Access Compliance Report

Public Rights-of-Way

(Curb Ramps)

Intersection ID: 54220	Main Street: SOUTH_REA_PARK_LN	Cross Street: SANDY_ROCK_PL	Location: SW
ADA ID: 54E8CF8745A8	Ramp Type: Perp	Initial Pass/Fail: Fail	Overall Compliance: No
Severity Score: 1.25			
Codes/Mitigation Info/Possible Solution		Field Measurements/Component Compliance

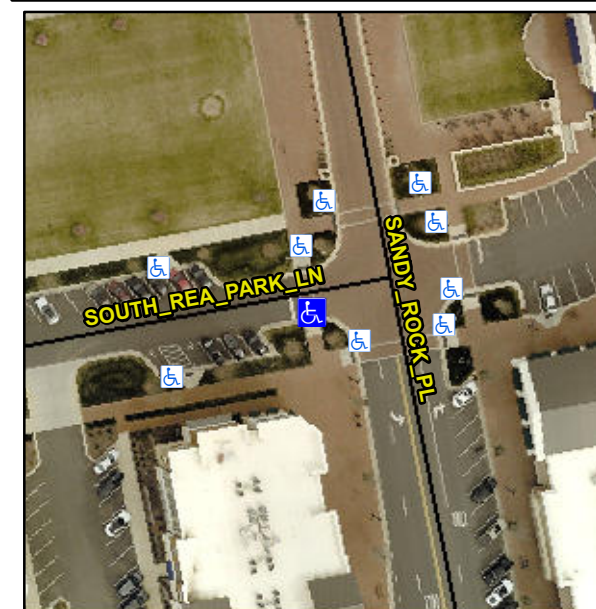
R304.5.3

Compliance	Description	Data	Compliance	Description	Data
N/A	Ramp Length (in)	88.0	Yes	Ramp Slope (%)	6.1
Yes	Ramp Width (in)	93.0	No	Ramp XSlope (%)	2.9
N/A	Flare Type LT	N/A	N/A	Flare Type RT	N/A
N/A	Flare Slope LT (%)	N/A	N/A	Flare Slope RT (%)	N/A
N/A	Flare Traversable LT?	N/A	N/A	Flare Traversable RT?	N/A
N/A	Landing Length (in)	N/A	N/A	DWS Provided?	N/A
N/A	Landing Width (in)	N/A	N/A	DWS Contrast?	N/A
N/A	Landing Slope (%)	N/A	N/A	DWS Length (in)	N/A
N/A	Landing X Slope (%)	N/A	N/A	DWS Full Width?	N/A
N/A	Landing Curb? (Y/N)	N/A	N/A	DWS Offset (in)	N/A
N/A	Shared Landing?	N/A			
N/A	Gutter Ponding?	N/A	N/A	Gutter Slope (%)	N/A
N/A	Gutter Lip Ht (in)	N/A	N/A	Gutter X Slope (%)	N/A
N/A	Painted X Walk1?	Yes	N/A	Painted X Walk2?	N/A
	X Walk 1 Direction	To N		X Walk 2 Direction	N/A
N/A	X Walk 1 Width (in)	77.5	N/A	X Walk 2 Width (in)	N/A
	X Walk 1 Slope (%)	2.0		X Walk 2 Slope (%)	N/A
	X Walk 1 X Slope (%)	2.6		X Walk 2 X Slope (%)	N/A

Remove & Replace Entire Ramp.
